<p>To: Planning Commission, Council, and Staff</p> <p>City of Stacy</p> <p>File: 193804175</p>	<p>From: Dan D. Boyum City Engineer</p> <p>Stantec Consulting Ltd.</p> <p>Date: July 15, 2021</p>
--	---

Reference: Site Plan Review – Stacy Indoor & Outdoor Storage – 5500 Block of Sherman Oaks Road

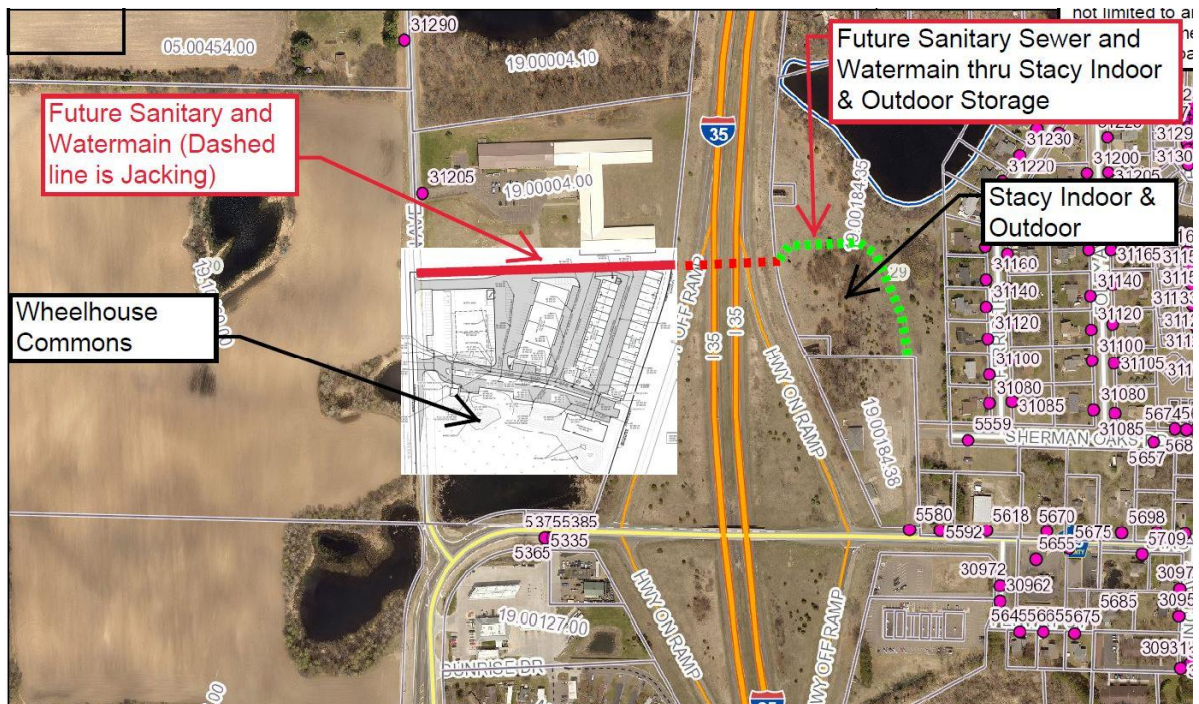
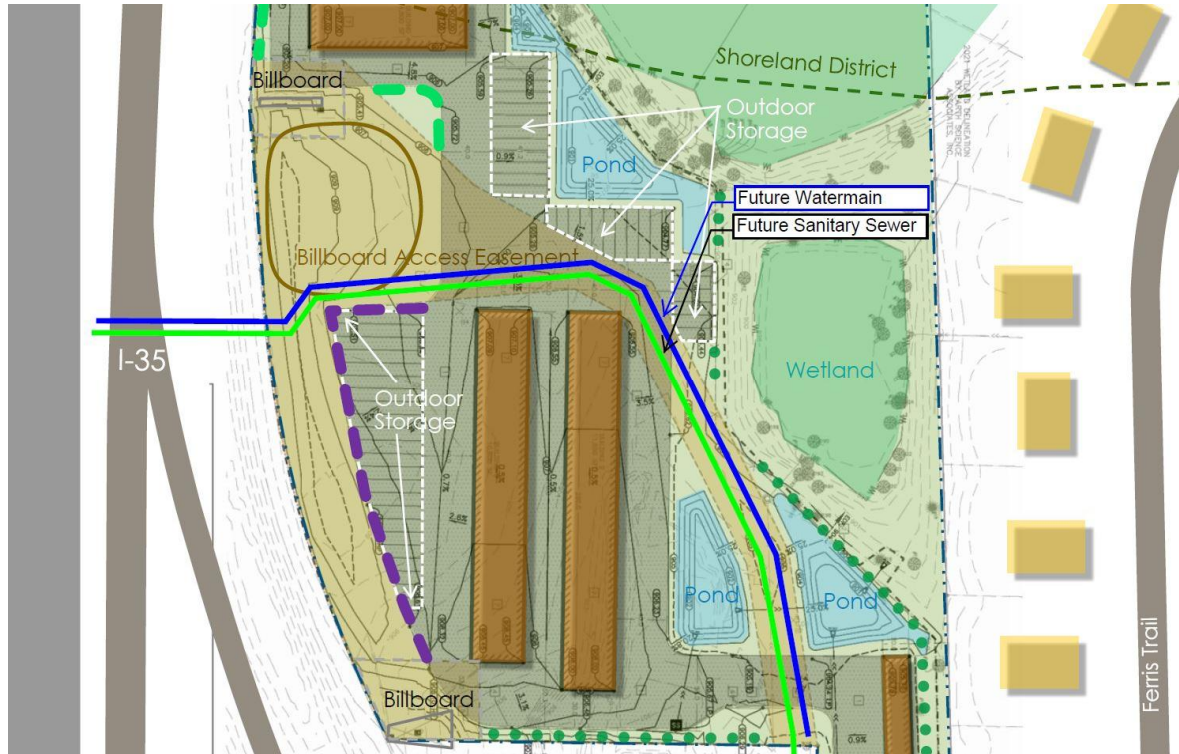
1. The city has looked for future sanitary sewer and water crossing routes of I-35 in the past. Sewer and water were extended north of Sherman Oaks Road as part of past developments. These utilities end near the south side of this property and the north side of the All-Mac property. The timing for extending those utilities to the west side of this property should be discussed as well as drainage and utility easements. See the two layouts below that show a possible routing for the future utilities.

4. Existing storm sewer piping and proposed new storm sewer piping cross the existing billboard easement. The existing billboard easement could be a route for future sanitary sewer and water as shown in the layouts above. Confirmation that new sanitary sewer and water could be placed in that existing billboard easement should be discussed as part of timing for those utilities. Obtaining drainage and utility easements around a sanitary sewer and water main route at this time would be recommended.
